Addendum No. # Two (2)

For: **PFD - Moon Island Seawall,**

Project No. **7222**

Item Three-Questions and responses:

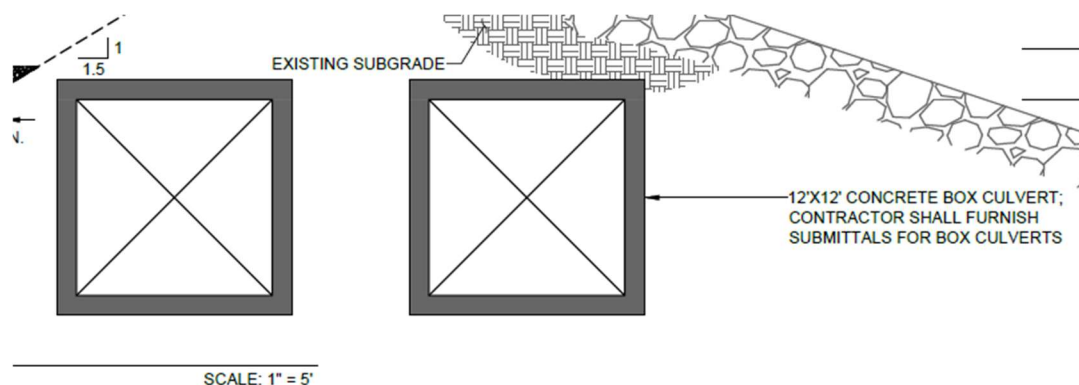
Question 8:

Can you please verify the dimensions of the box culverts? Is the 12' an interior dimension or an exterior dimension?

The only reason I'm asking is because the drawings scale to 10' interior length & height and the exterior dimensions scale to 12' length & height.

Response 8:

The intent was that the 12'x12' dimension is the exterior dimension of the box culverts.

Questions 17 &18

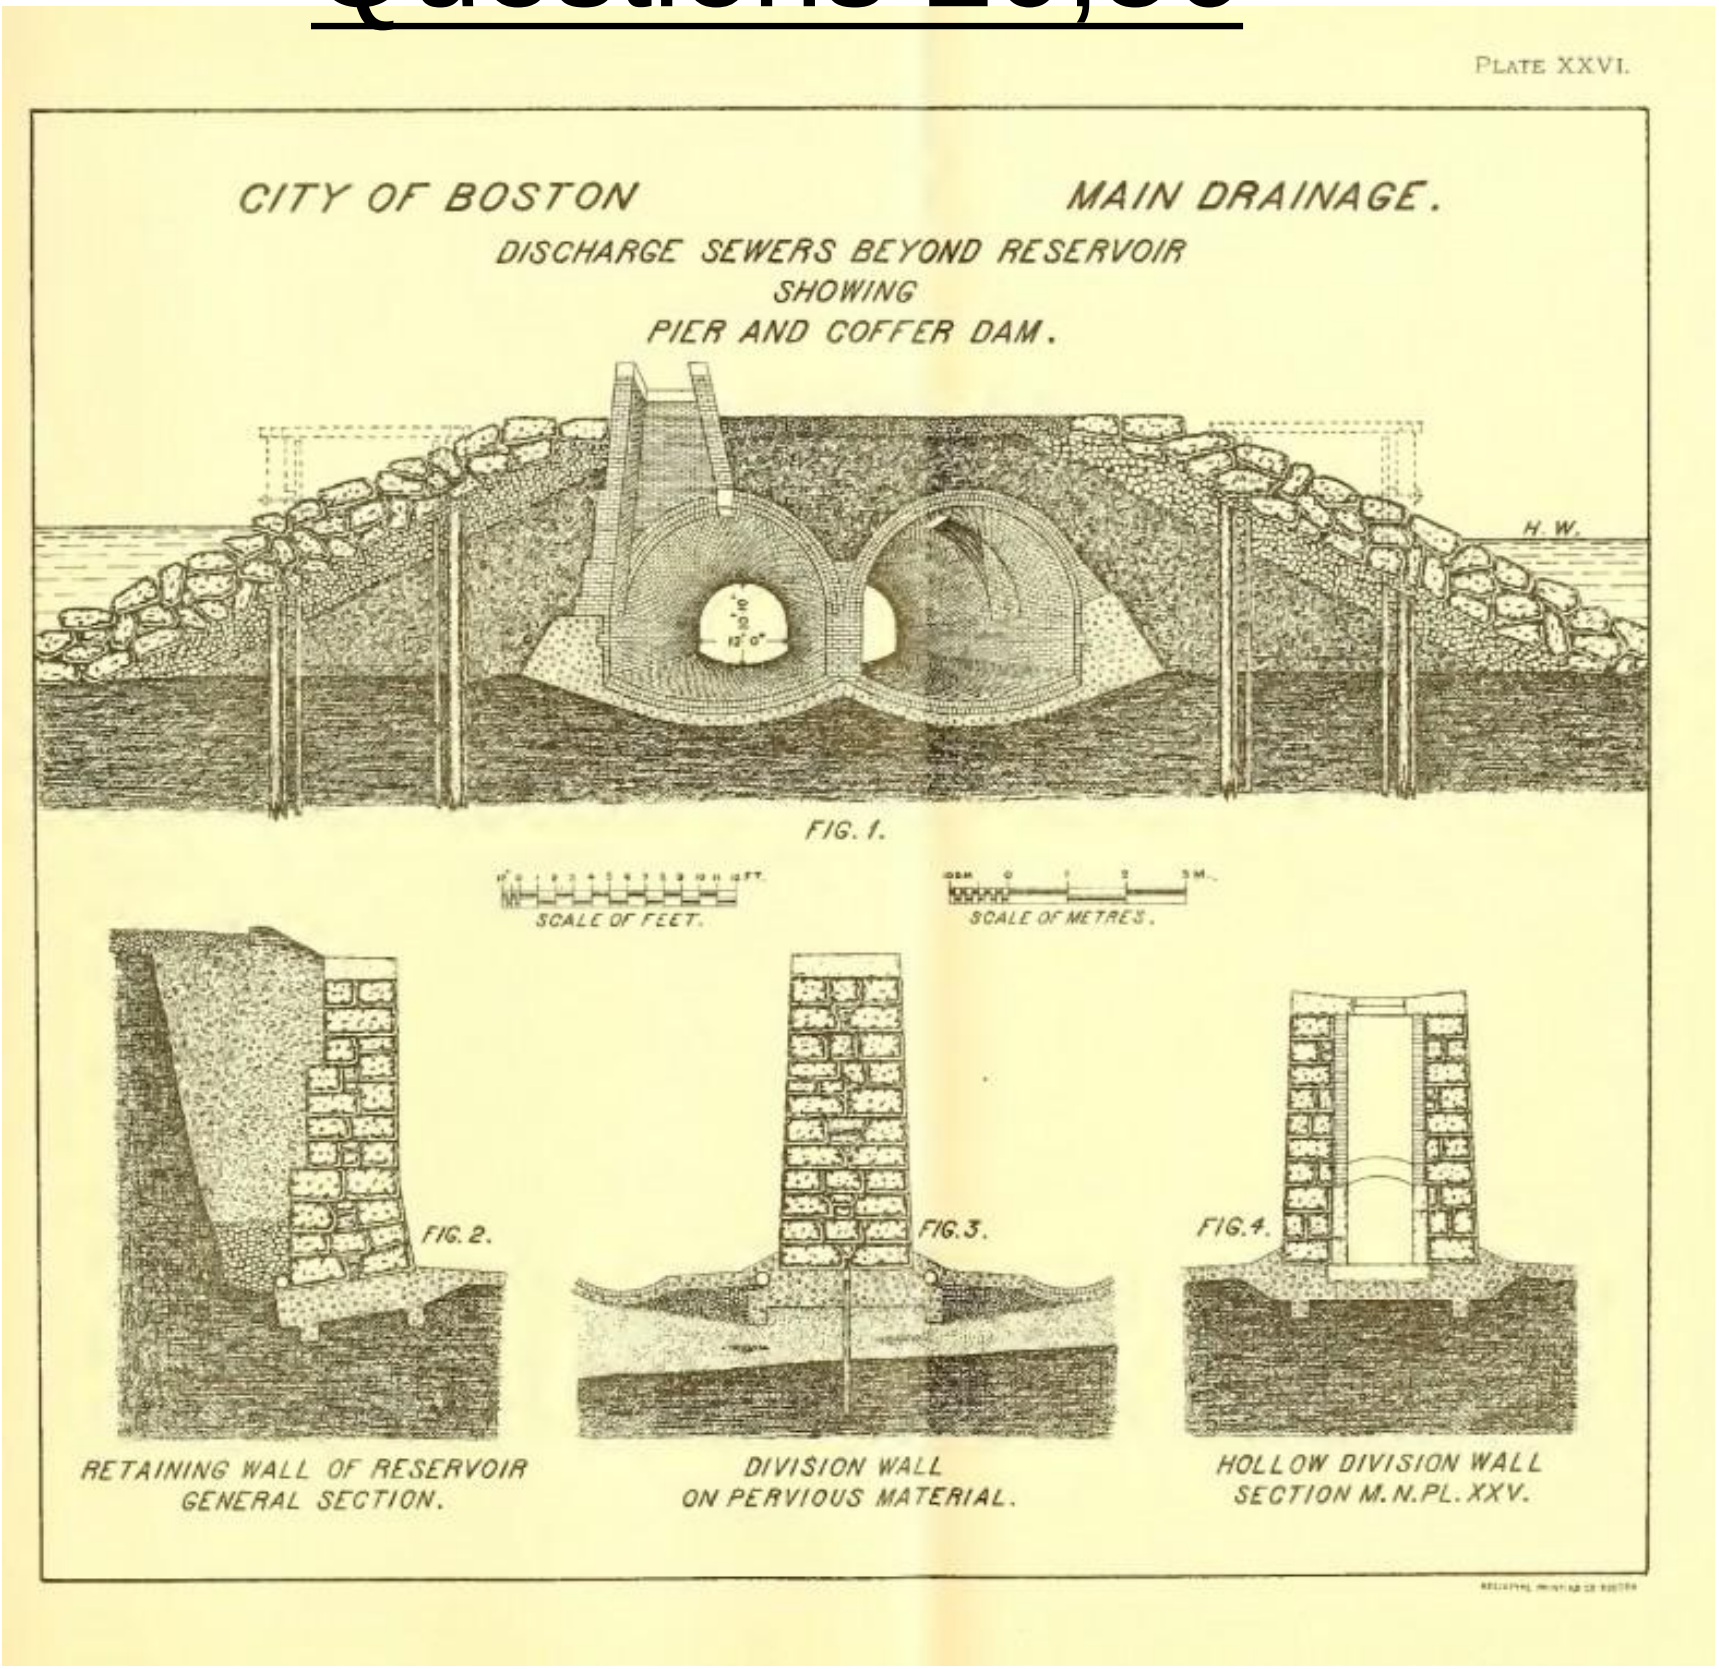
The specifications include section 32 92 33 – Sod Lawn, but we find no mention of a sod lawn to be installed on the plans. Please clarify where this is to be installed.

The specifications include section 32 93 00 – Plantings, but we find no mention of a plant list or landscaping plan included in the plans. Please clarify what plants are required and where they are to be installed.

Plants shall be installed in the northwest corner of the site adjacent to the proposed three-sided box culvert area, as required to restore disturbed areas following construction and to follow the spec section. Please see attached pdf which shows the area identifying the sod and plant installation. (See exhibit D)
